25240 - NAVAJO NATION PEACEMAKING BUILDING & AMPITHEATER

Addendum **ADD-1.0**

ADDENDUM 001

See attached revised drawings to address recent plan check comments and questions from bidders.

C2 AMPHITHEATER GROUNDING DIAGRAM

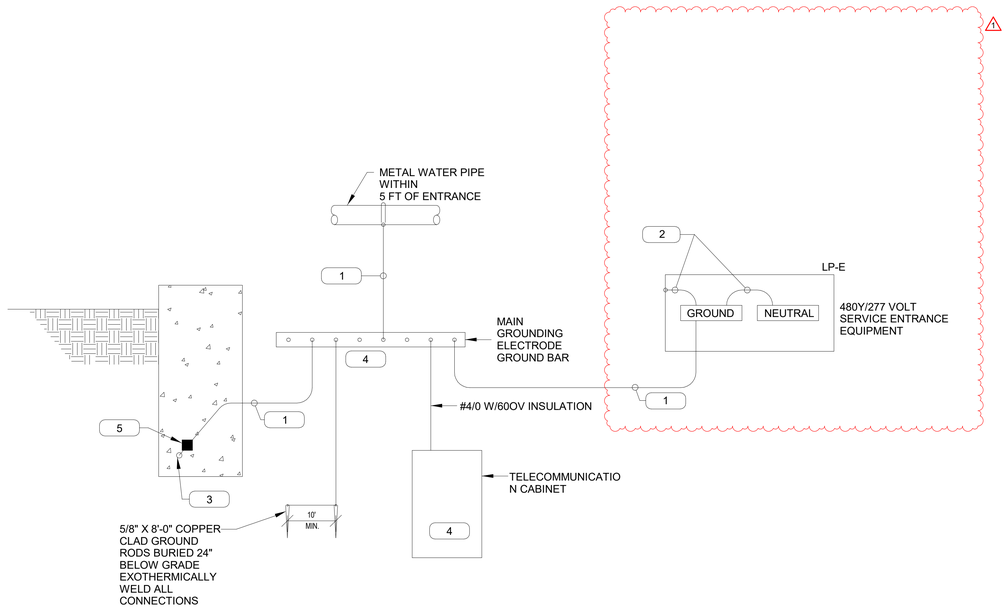
Sheet E600.3: Amphitheater Grounding Diagram

A5 OVERALL ELECTRICAL SITE PLAN

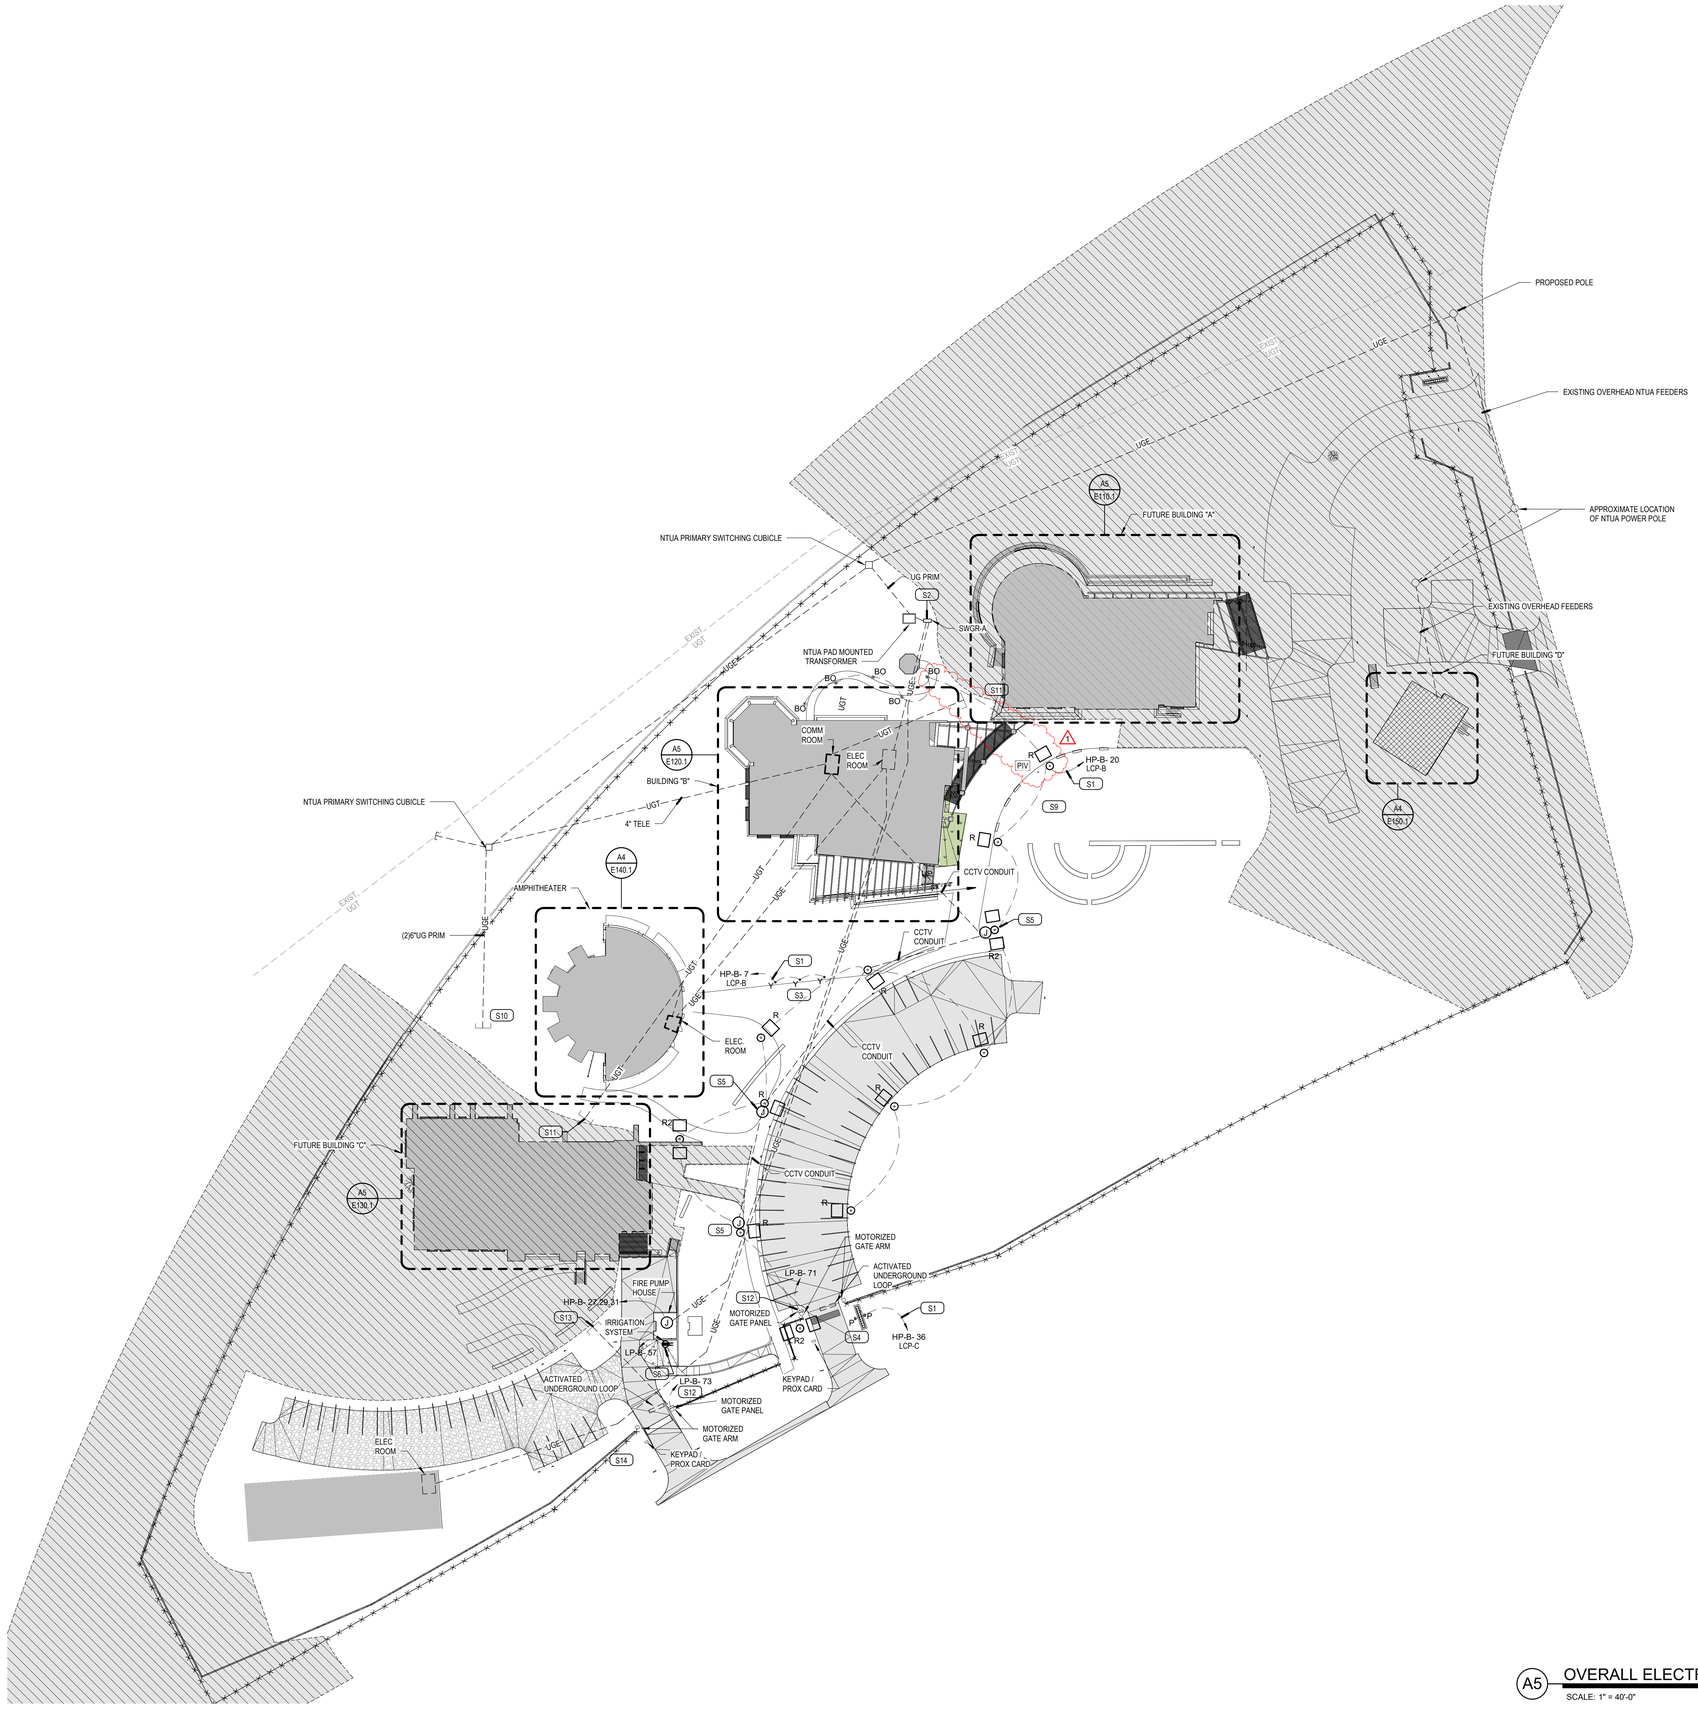
11	There are 5ea BO fixtures shown on ES100.1 that are not on the fixture schedule. Can you get me a specified part number for them.	The Lighting Fixture Schedule has been updated to include fixture BO and the approved Manufactures on Sheet E600.6 in Addendum 01. The Above All LED Moon is the Basis of our design.		
	12	Is Heat Soaking required for the tempered glass	Section 08 80 00 2.4 B 2 states that heat soaking is required		
	13	Specs show VNE1-53 but drawings show Solarban70, which is to be used	Solarban 70 (Vitro) on clear, as indicated on the Drawings, is the basis of design. Section 08 8000 will be revised by Addendum to list Solarban 70, with Viracon and other listed manufacturers acceptable if they meet its published VLT, SHGC and U-value.		
	14	Drawings callout Curtainwall at some elevations but no Curtainwall spec was provided and none of these windows require to be curtainwall. Is it storefront but with the glazing plane as the front	There is no "curtainwall". Everything is storefront with the glazing plane to the front for B3 and glazing to the center for the remainder of the windows

Sheet ES100.1: Overall Electrical Site Plan
